Access Compliance Report

Intersection ID: 27028	Main Street: HICKORY_FOREST_DR	Cross Street: STEVENSVILLE_LN	Location: NE
ADA ID: 70D1B7D47220	Ramp Type: BlendTrans1	Initial Pass/Fail: Fail	Overall Compliance: No
		Severity Score: 10

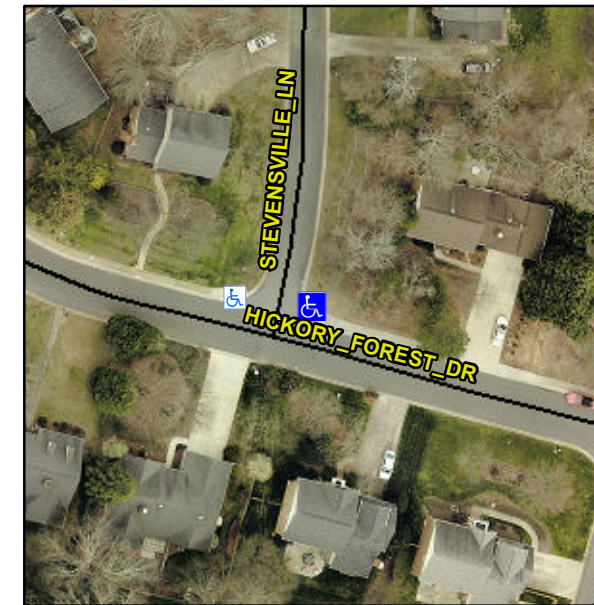
Not Found, R304.5.1, R304.5.3

Compliance	Description	Data	Compliance	Description	Data
N/A	Ramp Length (in)	34.0	Yes	BlendTrans Slope (%)	2.5
No	Ramp Width (in)	47.0	No	BlendTrans XSlope (%)	3.2
N/A	Flare Type LT	N/A	N/A	Flare Type RT	N/A
N/A	Flare Slope LT (%)	N/A	N/A	Flare Slope RT (%)	N/A
N/A	Flare Traversable LT?	N/A	N/A	Flare Traversable RT?	N/A
N/A	Landing Length (in)	N/A	N/A	DWS Provided?	N/A
N/A	Landing Width (in)	N/A	N/A	DWS Contrast?	N/A
N/A	Landing Slope (%)	N/A	N/A	DWS Length (in)	N/A
N/A	Landing X Slope (%)	N/A	N/A	DWS Full Width?	N/A
N/A	Landing Curb? (Y/N)	N/A	N/A	DWS Offset (in)	N/A
N/A	Shared Landing?	N/A			
N/A	Gutter Ponding?	N/A	N/A	Gutter Slope (%)	N/A
N/A	Gutter Lip Ht (in)	N/A	N/A	Gutter X Slope (%)	N/A
N/A	Painted X Walk1?	No	N/A	Painted X Walk2?	No
	X Walk 1 Direction	To W		X Walk 2 Direction	To S
	X Walk 1 Width (in)	N/A		X Walk 2 Width (in)	N/A
	X Walk 1 Slope (%)	1.3		X Walk 2 Slope (%)	2.4
	X Walk 1 X Slope (%)	3.0		X Walk 2 X Slope (%)	0.1

N/A	Ramp inside XWalk1?	N/A	N/A	Ramp inside XWalk2?	N/A
	Road Slope (%)	3.1		Clear Space?	N/A
	Road X Slope (%)	3.1	N/A	Clear Space to XWalk (in)	N/A
N/A	Any Obstructions?	N/A	N/A	Storm Grate/Utility Hazard?	N/A
	Obstruction Type			Storm Grate/Utility Type	
		N/A			N/A
			Yes	Surface Condition? (G/P)	Good
			No	Curb Slope (%)	5.5

Remove & Replace Curb Ramp With Two New Directional Ramps or Equivalent.
